# Addendum 04

**PROJECT:** Fort Loramie Local Schools Athletic Complex Building & Associated Improvements  
600 East Park Street  
Fort Loramie, Ohio 45845

**PROJECT #:** 25041.00

SHEET NUMBER:  
**S3.1**

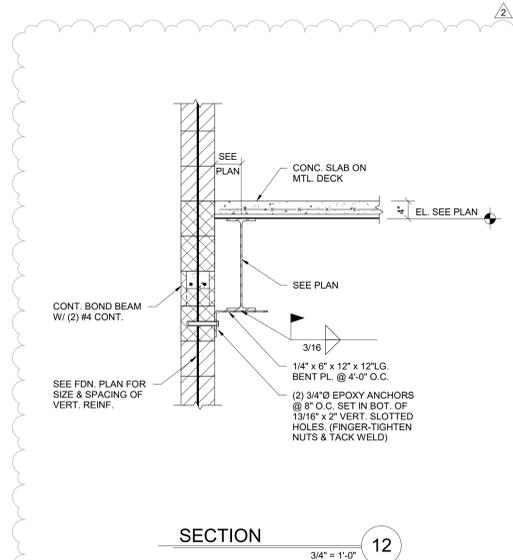
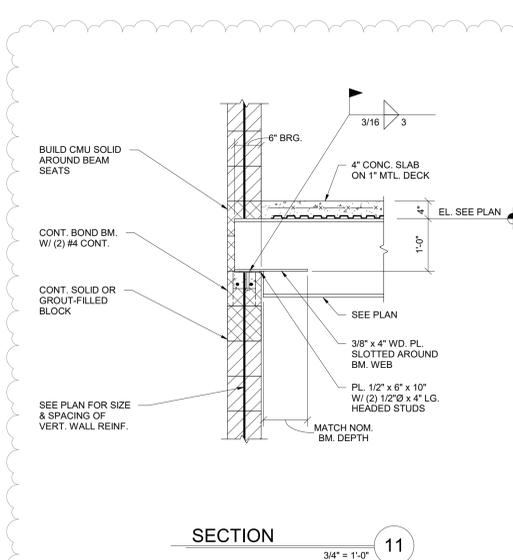
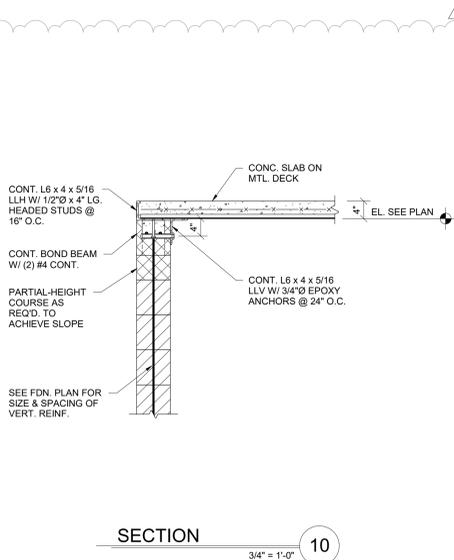
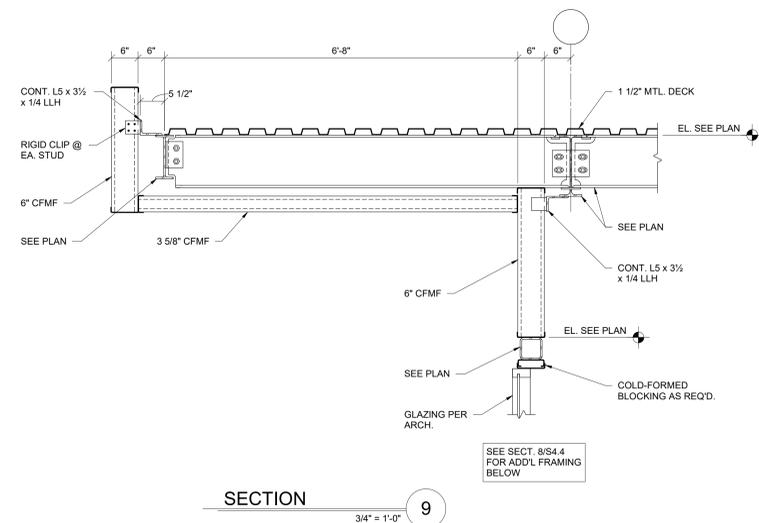
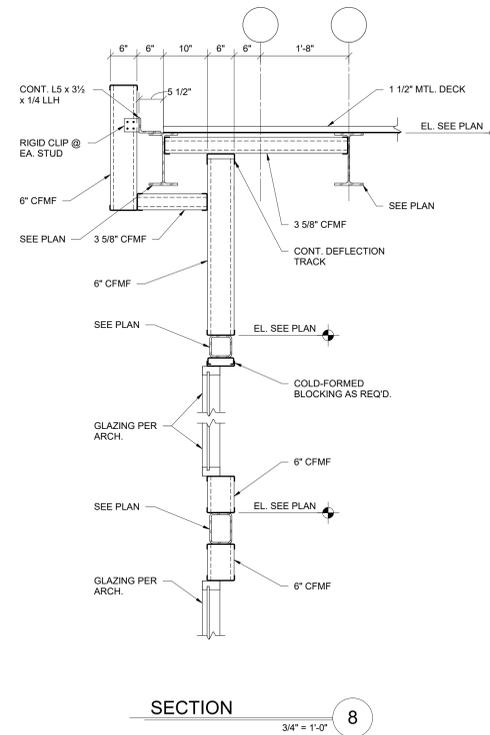
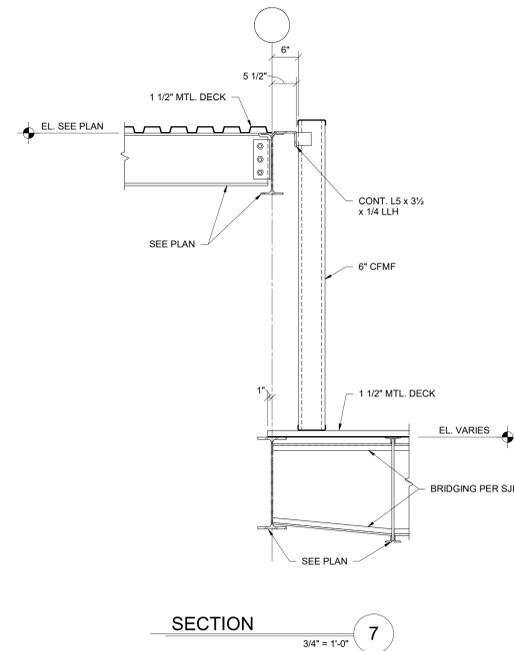
- a. Added foundation walls and recessed slab at new Lift A122.
14. Sheet S3.1 – Framing Plan
  - a. Added walls and details around new Lift A122.
  - b. Adjusted Framing due to new lift A122

SHEET NUMBER:  
**S4.4**

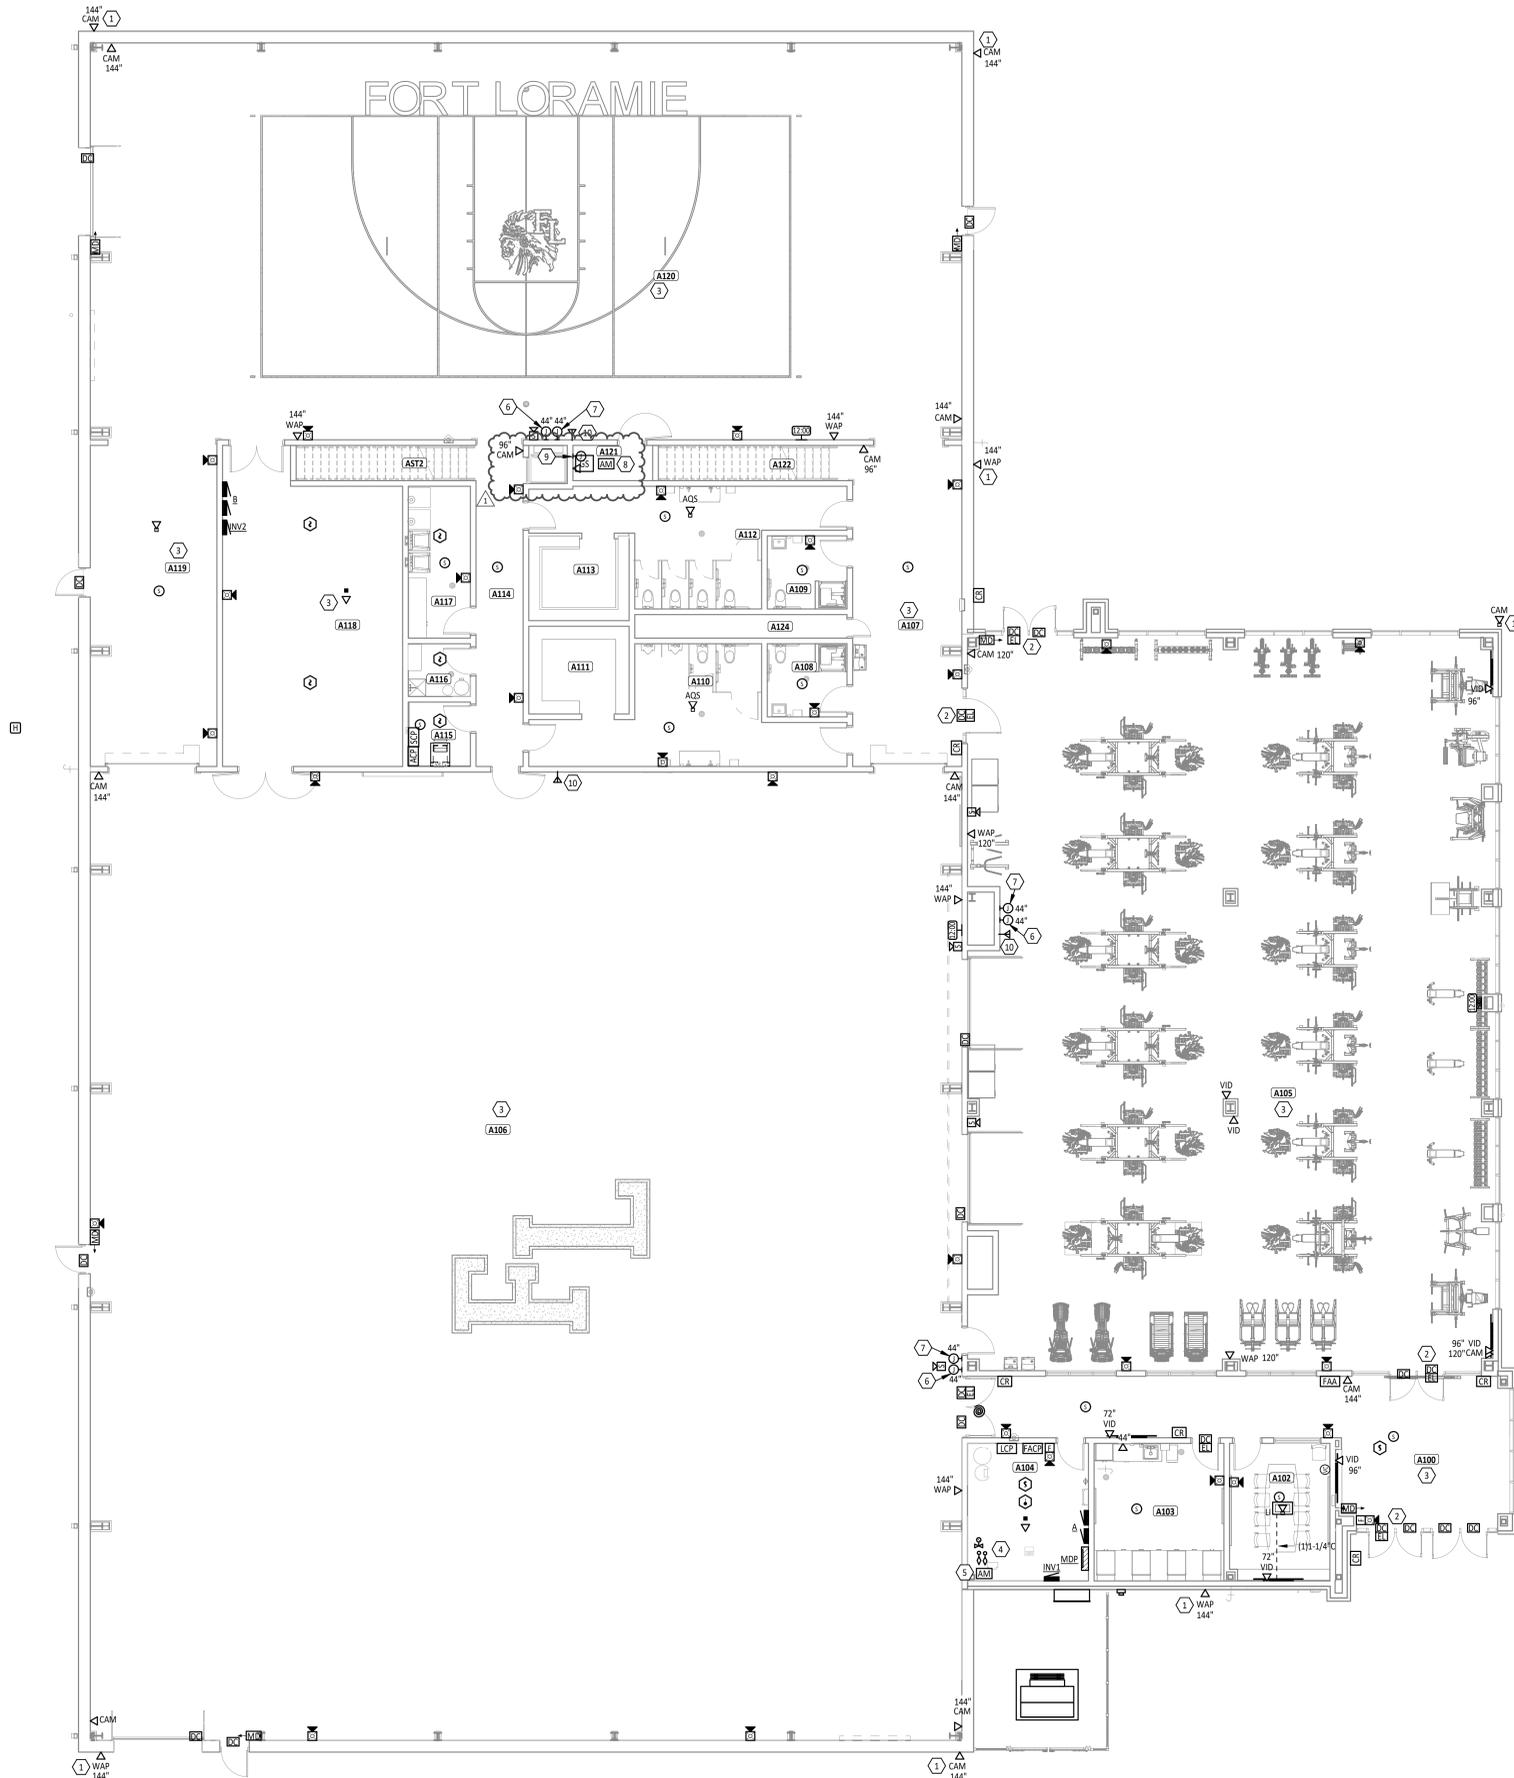
15. Sheet S4.4 – Framing Details
  - a. Added Sections 10,11, and 12 for new lift A122
16. Sheet E3.1 – First Floor Systems Plans
  - a. Relocated sound system equipment in A121 to accommodate vertical lift.

SHEET NUMBER:  
**E4.1**

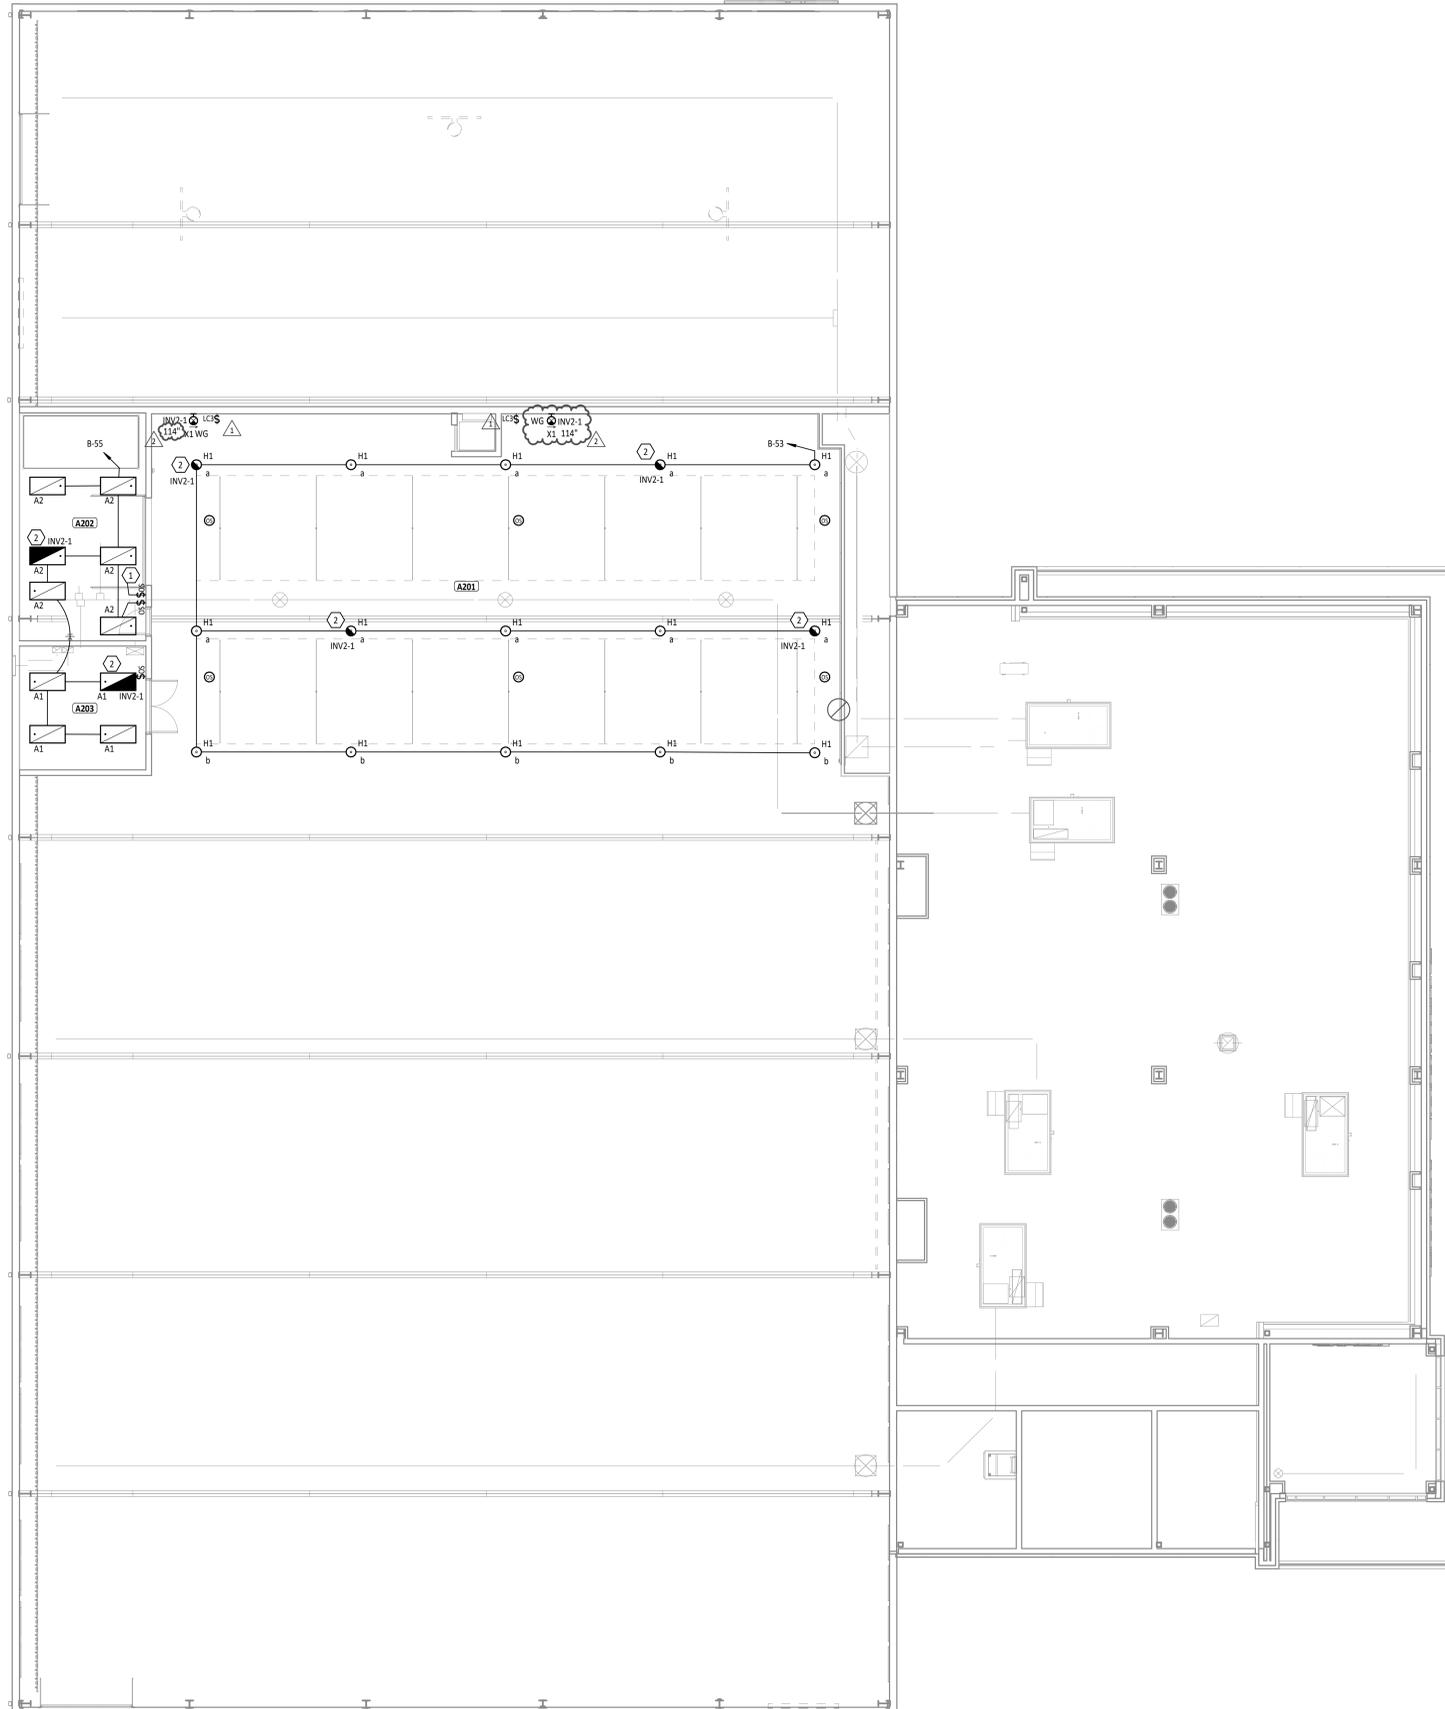
17. Sheet E4.1 – First Floor Lighting Plan
  - a. Relocated light fixture and lighting control device in A121 to accommodate vertical lift.
18. Sheet E4.2 – Second Floor Lighting Plan

SHEET NUMBER:  
**E4.2**

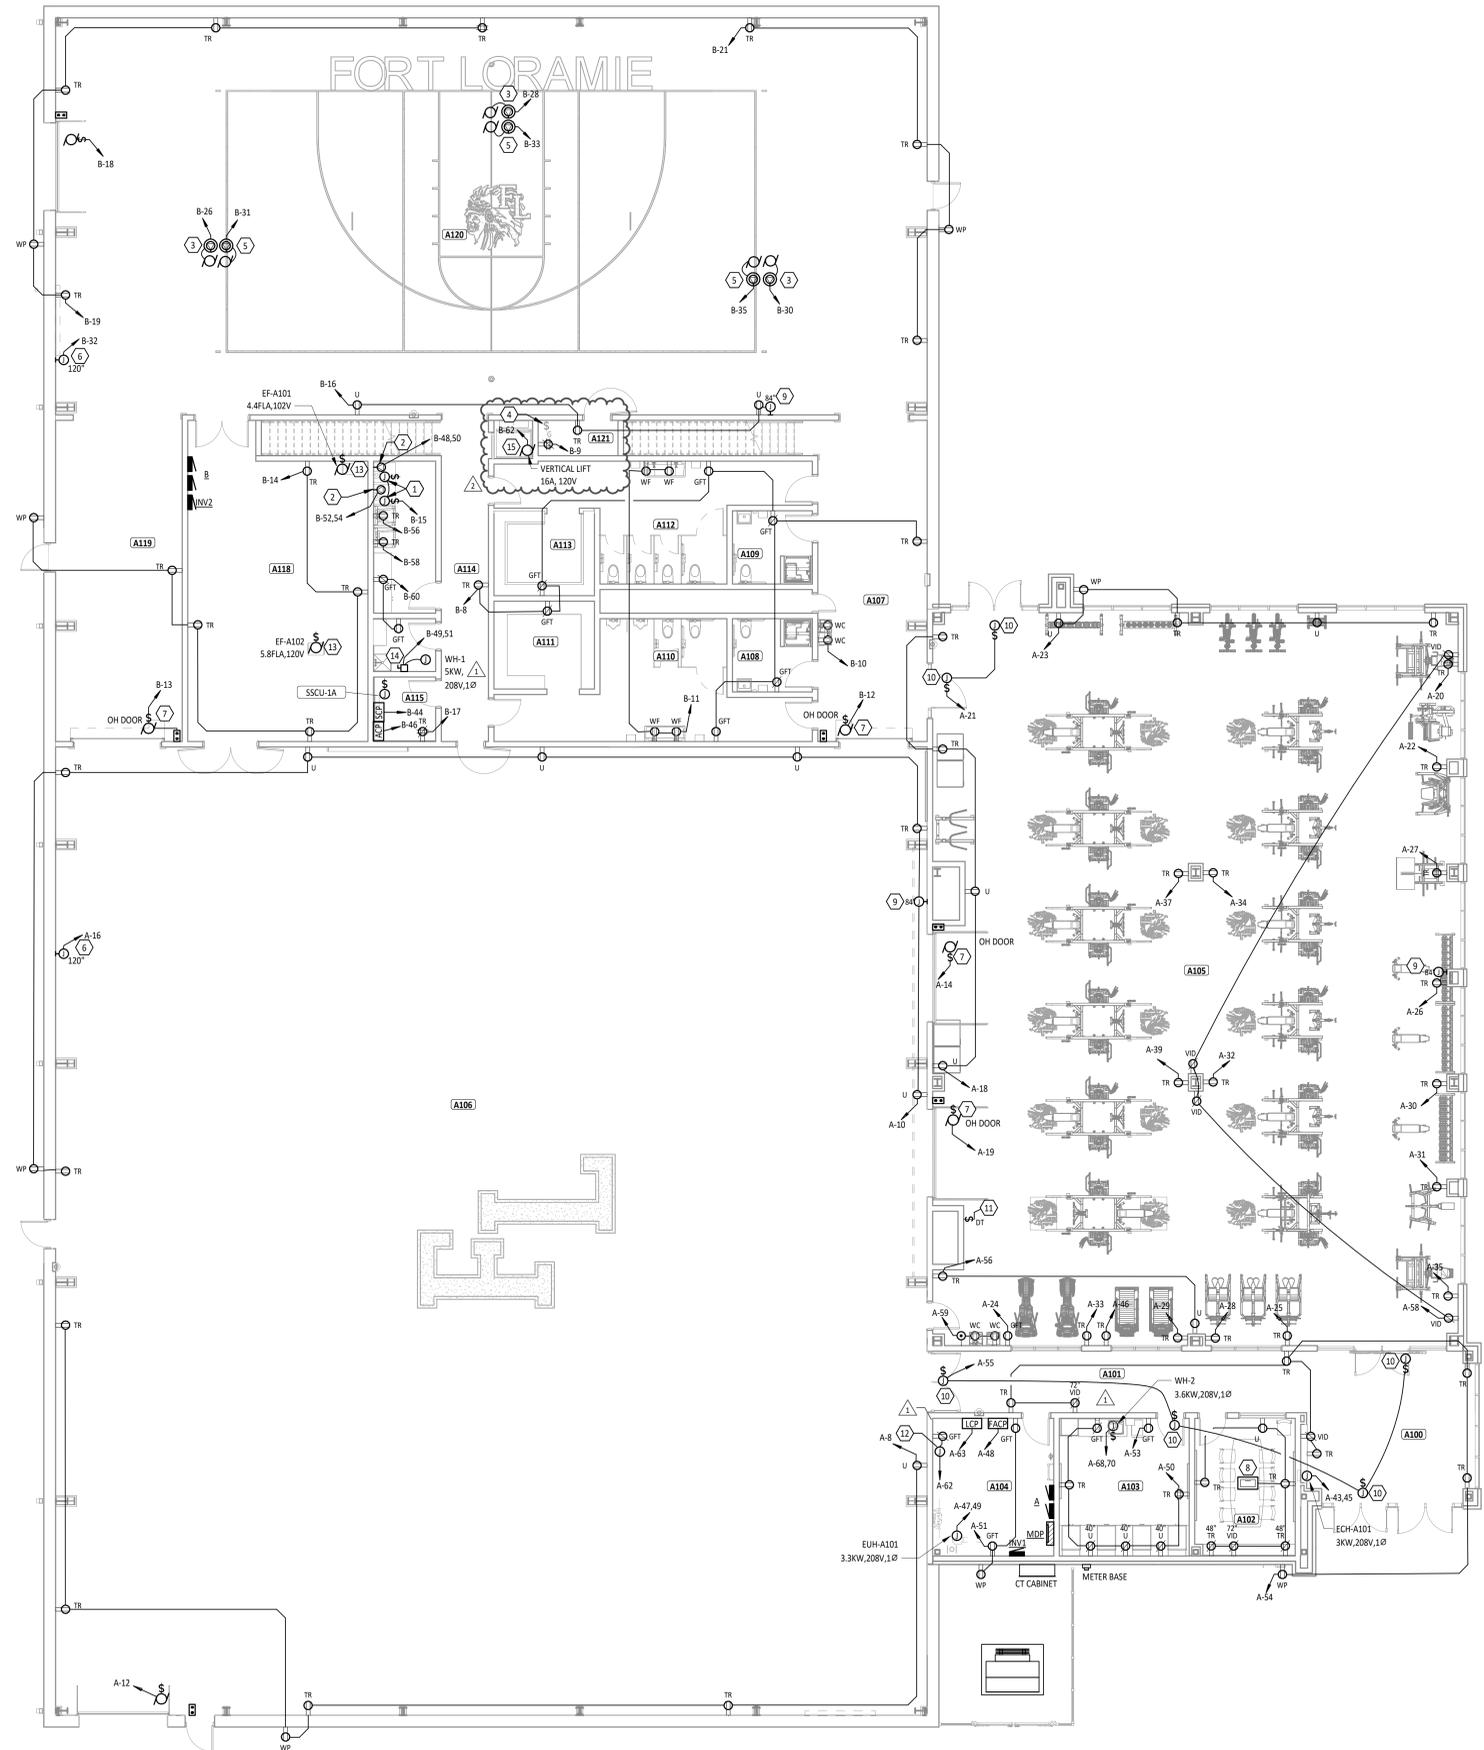
- a. Relocated exit sign in A201 to accommodate vertical lift.
  - b. Provided mounting heights for exit signs in A201.
19. Sheet E5.1 – First Floor Power Plan
